RESPONSE TO SUBMISSIONS DESIGN REPORT

1 BARRACK LANE, 81-83 GEORGE ST, PARRAMATTA

APRIL 2026

2.3 AMENITIES - LEVEL 03

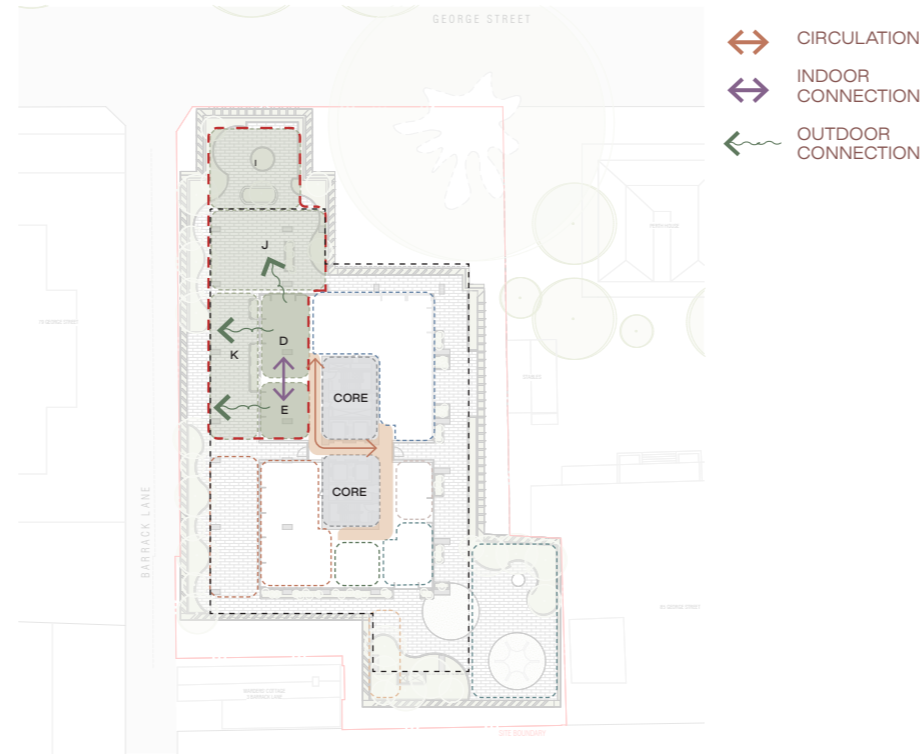
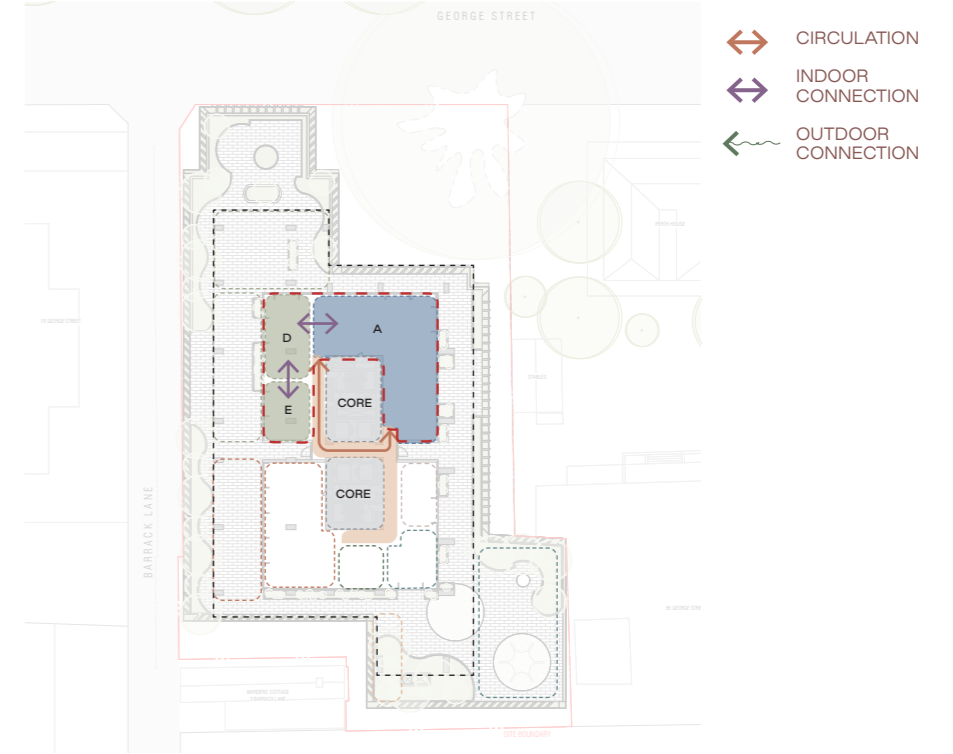
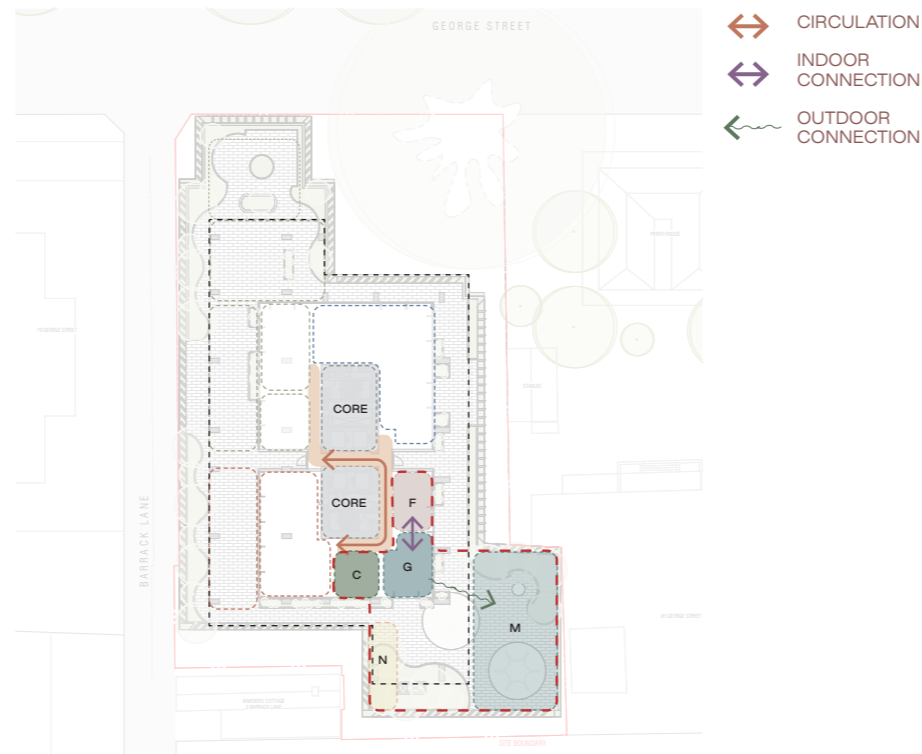
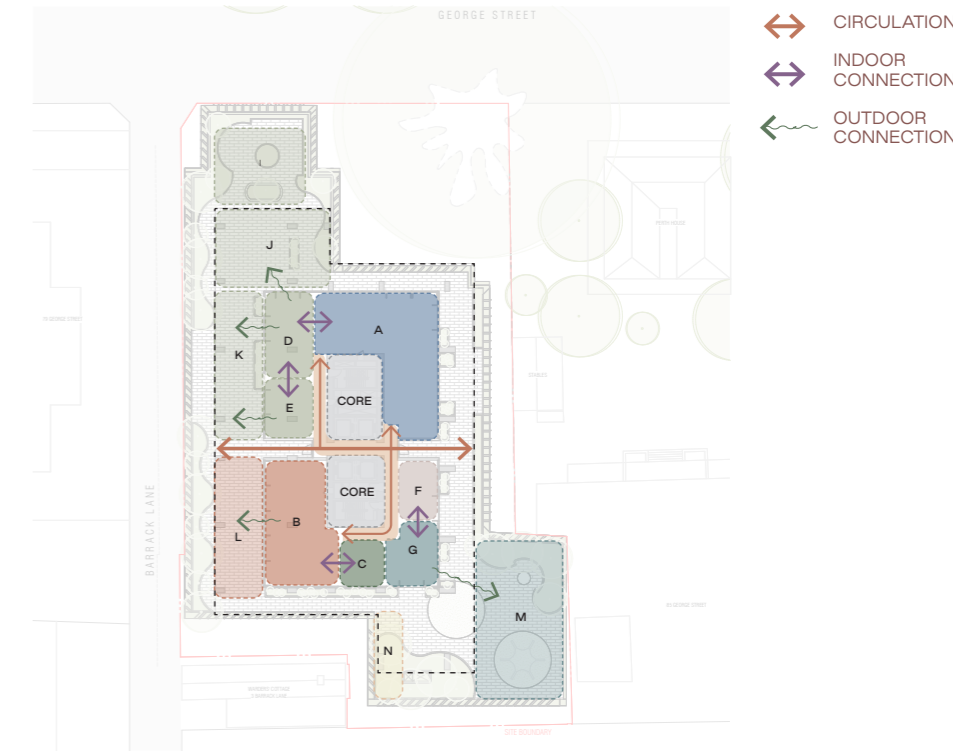
DPHI - 6

Level 03 has been further developed to clearly define the resident amenity offering, informed by market research and operational requirements. The primary demand identified was for co-working and gym facilities, and these uses anchor the amenity floor.

Additional spaces include indoor and outdoor lounge areas, private dining rooms, family and children's rooms, and dedicated pet amenities. The diagrams illustrate the spatial relationships between these areas and their connection to adjoining terraces, demonstrating how internal and external spaces operate cohesively.

Amenities have been co-located to allow flexibility, enabling rooms to be combined for larger events or programmed activities. The lounge areas function as extensions of residents' private open space, providing a range of settings including internal, covered outdoor and fully open-air terraces with integrated BBQ facilities.

LEVEL 03 AMENITIES

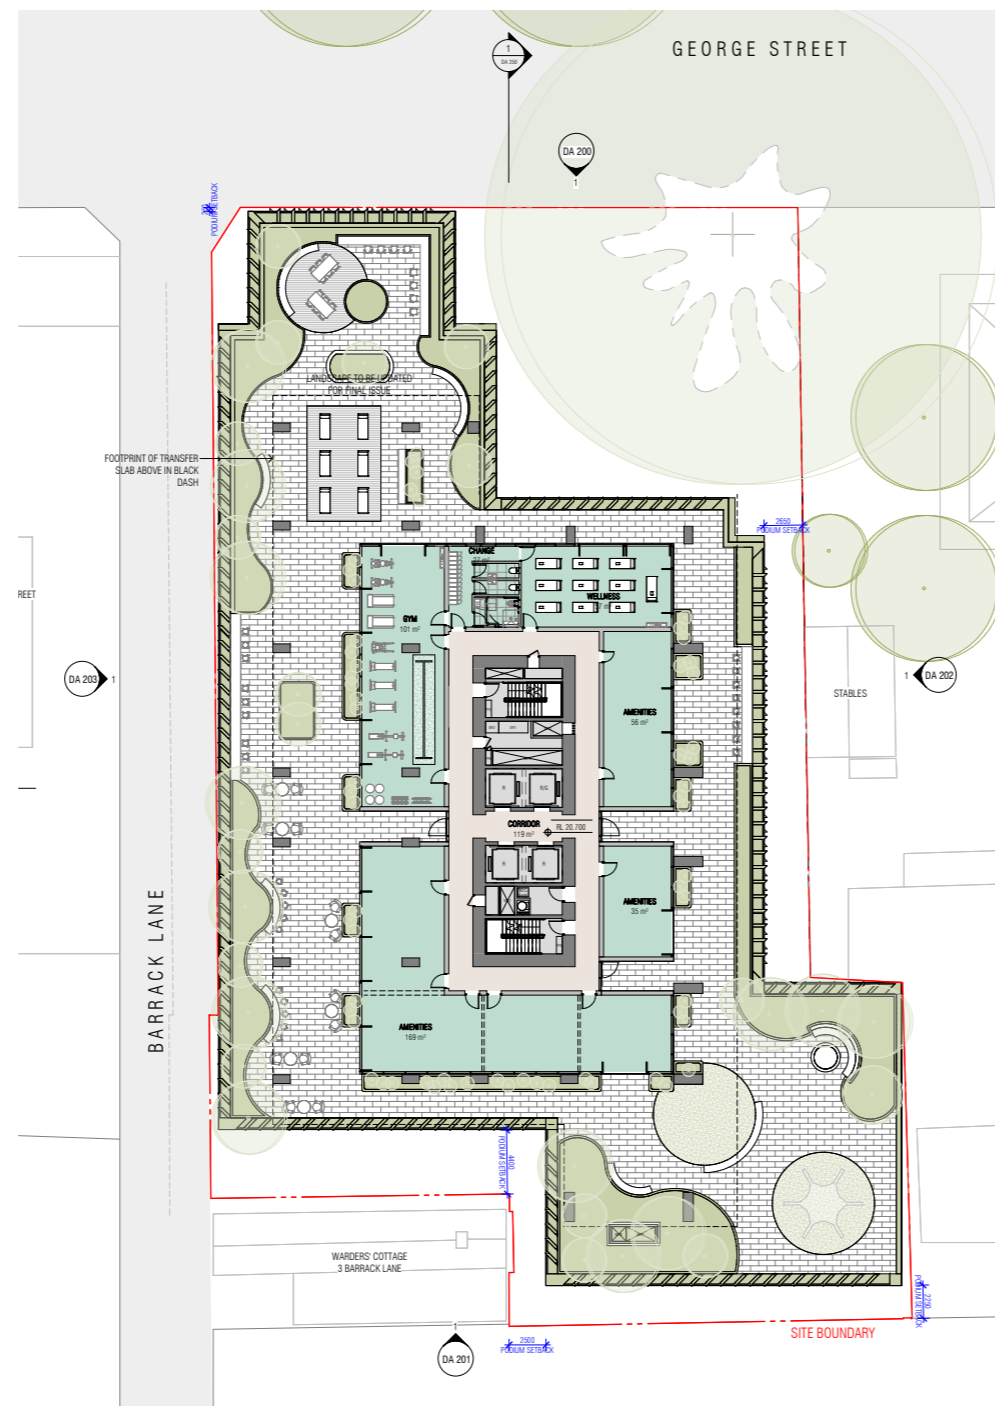
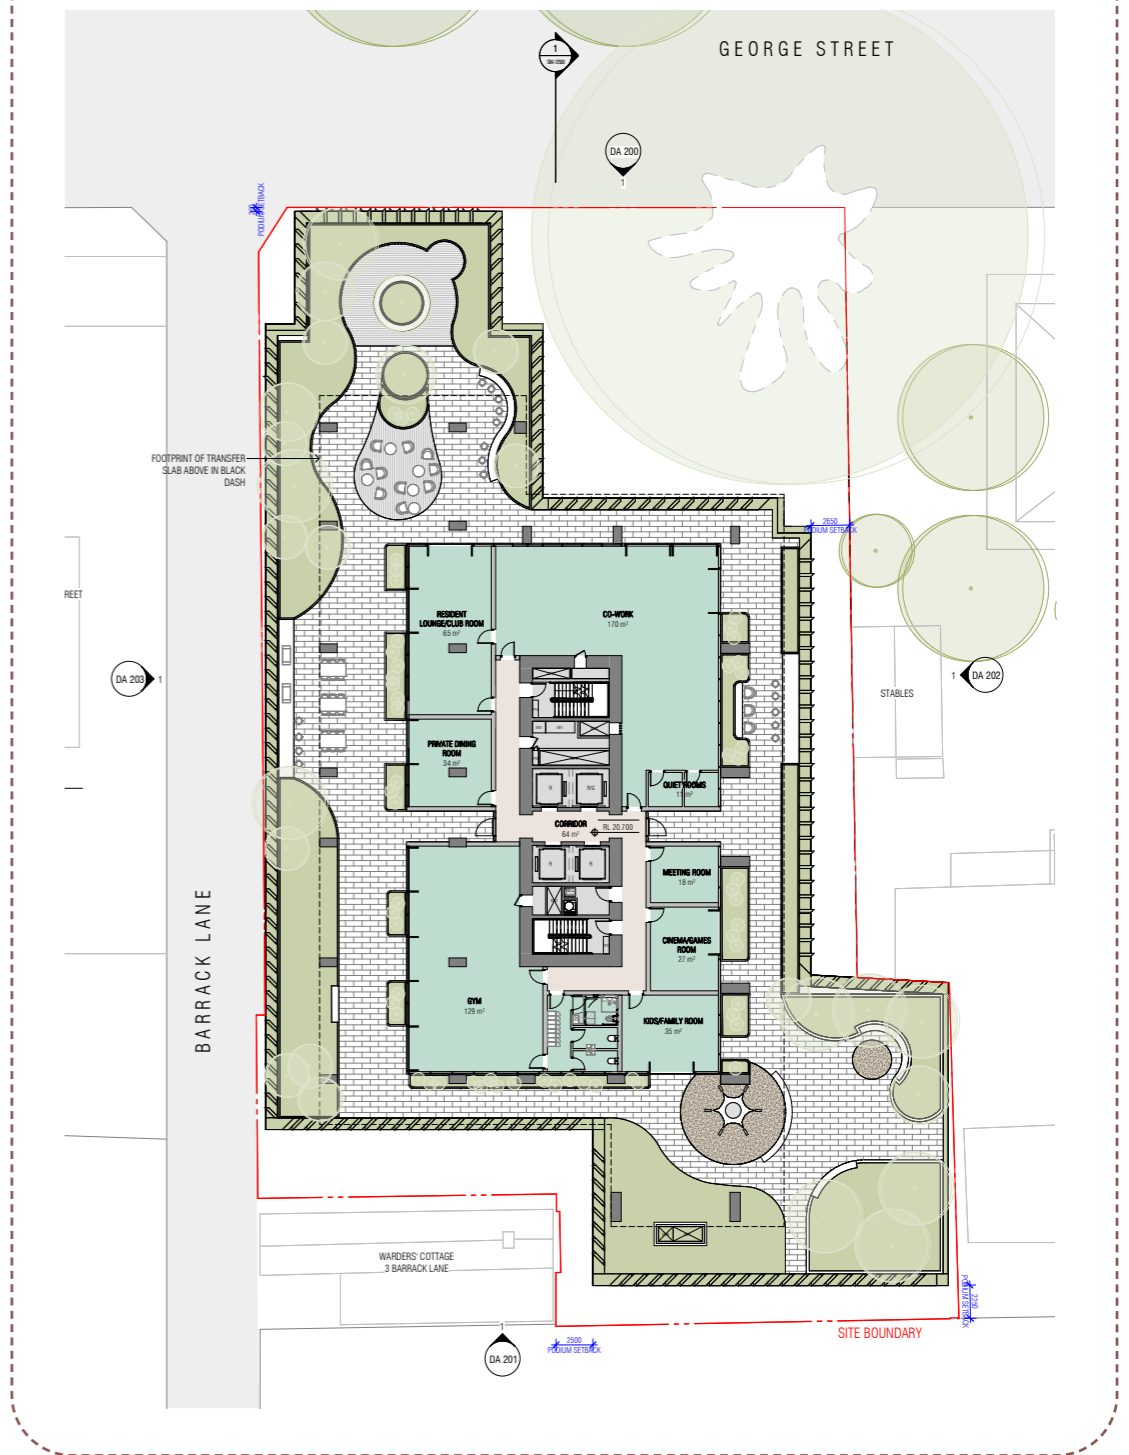
DPHI - 6

The Level 03 floor plan demonstrates the spatial organisation of the amenity zones and their relationship to the adjoining outdoor areas. The layout clearly illustrates how internal spaces connect to terraces to support flexible use and functional adjacency.

The landscape design has been revised in response to the updated layouts, ensuring alignment between built form, planting zones and outdoor amenity areas.

2.4 VISUAL PRIVACY

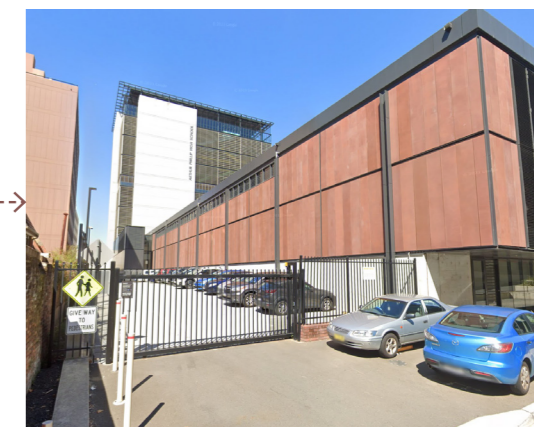
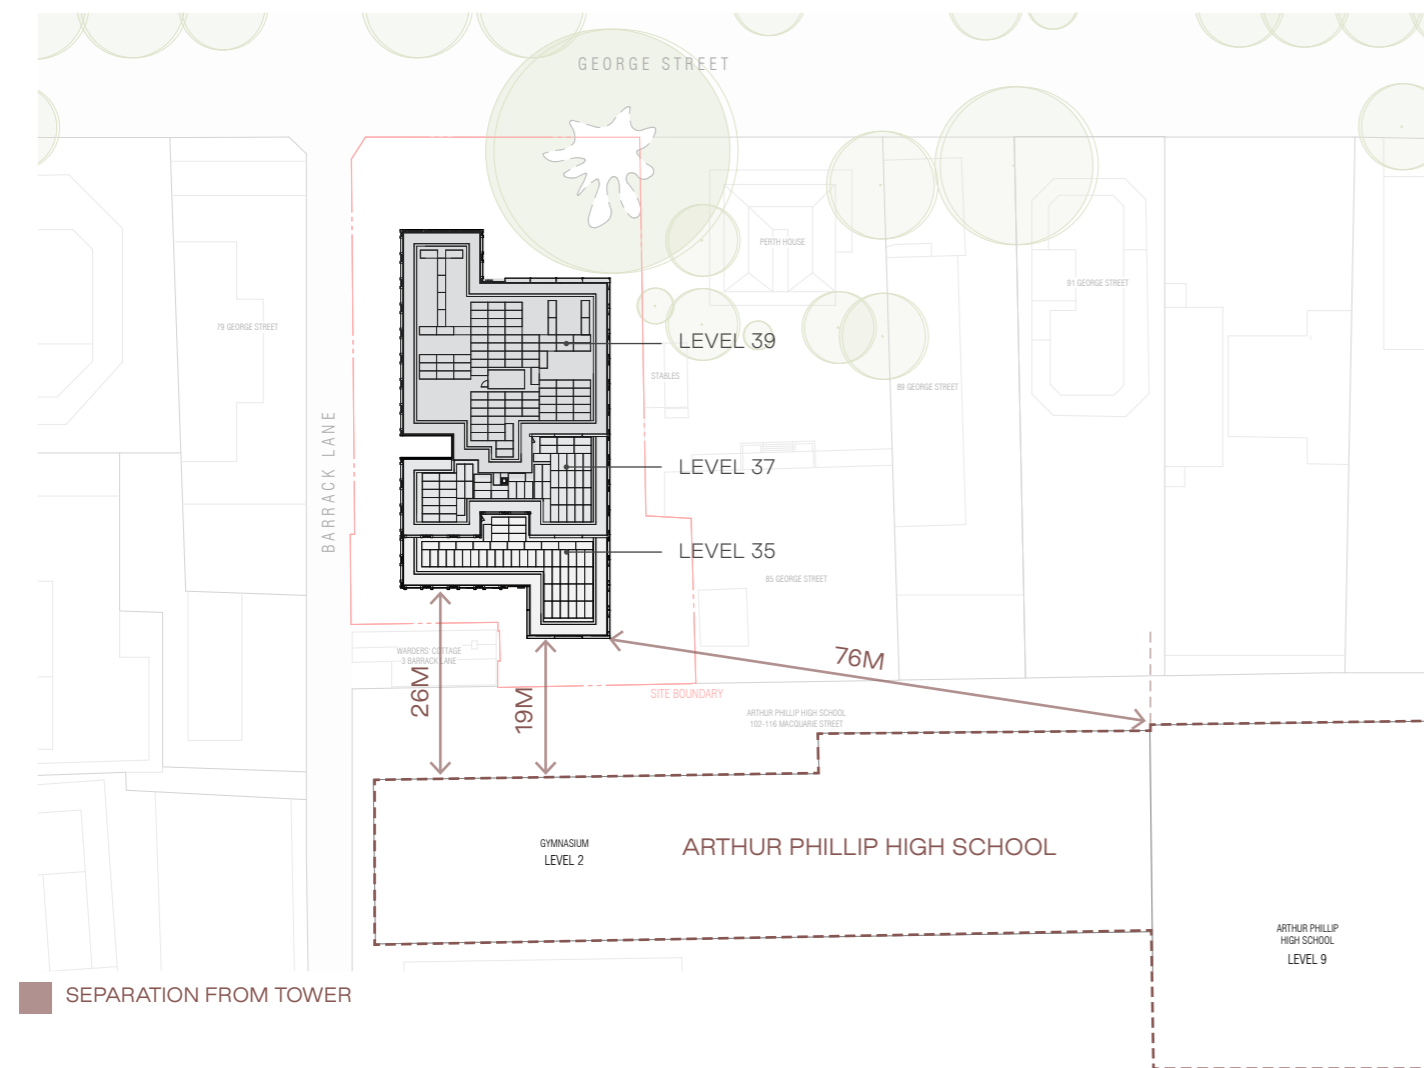
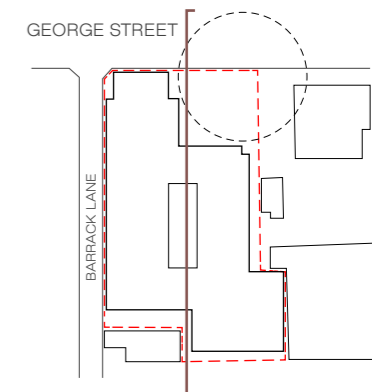
DPHI - 7

The proposed tower achieves glazing-to-glazing separation distances that exceed the 24 metre habitable façade separation recommended under the ADG. The primary Arthur Phillip High School buildings are located approximately 76 metres from the development.

Given the significant horizontal separation, the vertical scale of the tower, and the distance to active school areas, any views toward the school would be long-range and oblique

in nature. At this scale, individual students would not be clearly visible, and the proposal does not give rise to unreasonable privacy impacts.

2.5 OVERSHADOWING

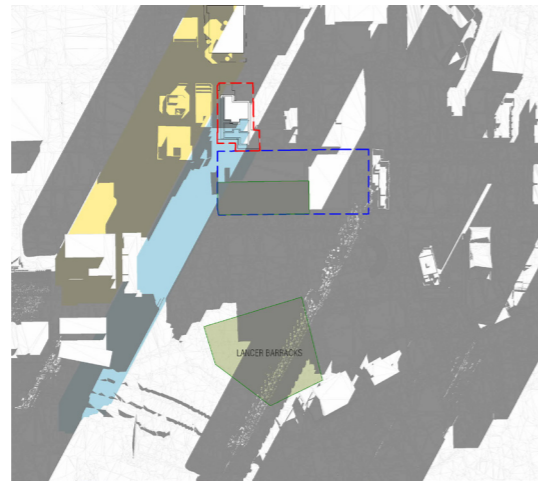
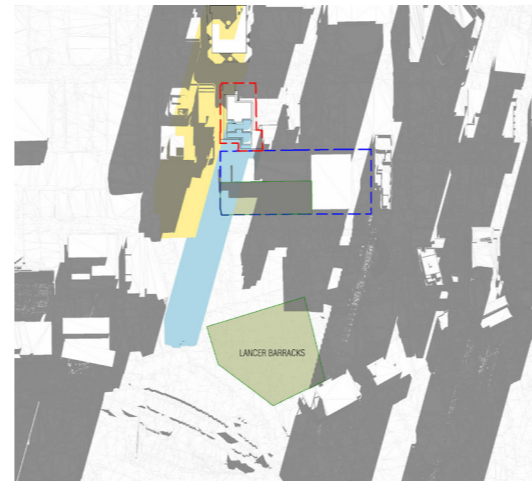
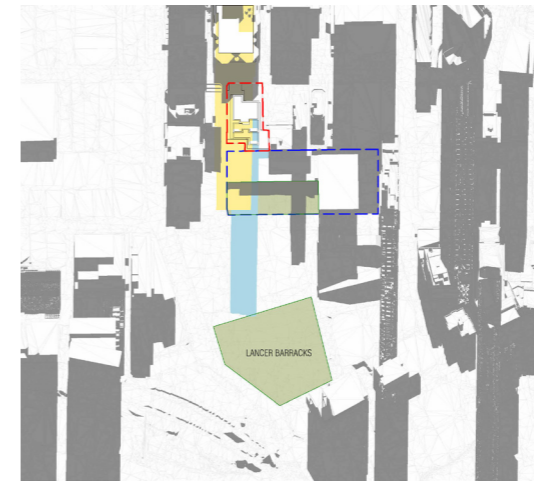
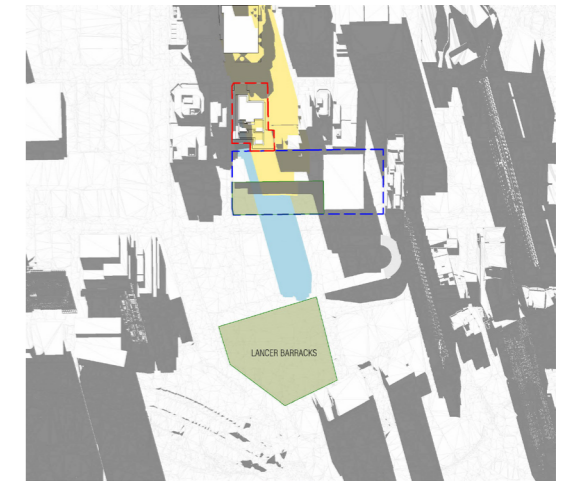
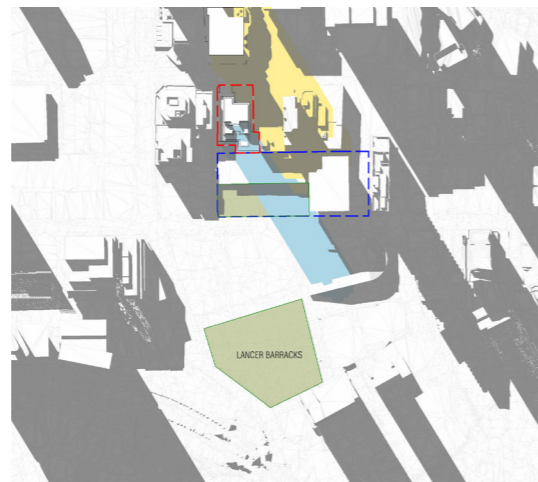
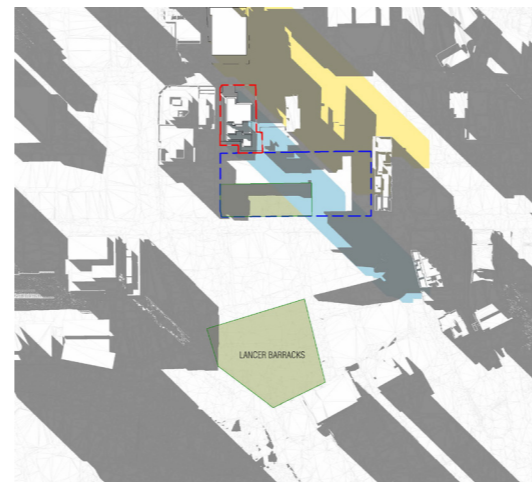
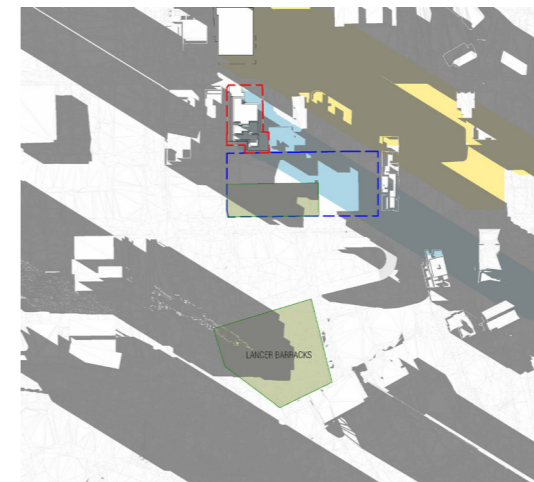
DPHI – 8
DoE – 4
DoE – 8

Detailed analysis of overshadowing to Arthur Phillip High School has been undertaken and is demonstrated in the accompanying shadow diagrams. The assessment identifies key recess periods for the school as 10:00–10:30am, 11:45am–12:15pm and 1:30–1:50pm.

Given the established CBD context and the presence of surrounding tall buildings, the additional shadow impact generated by the proposal is limited and not considered significant.
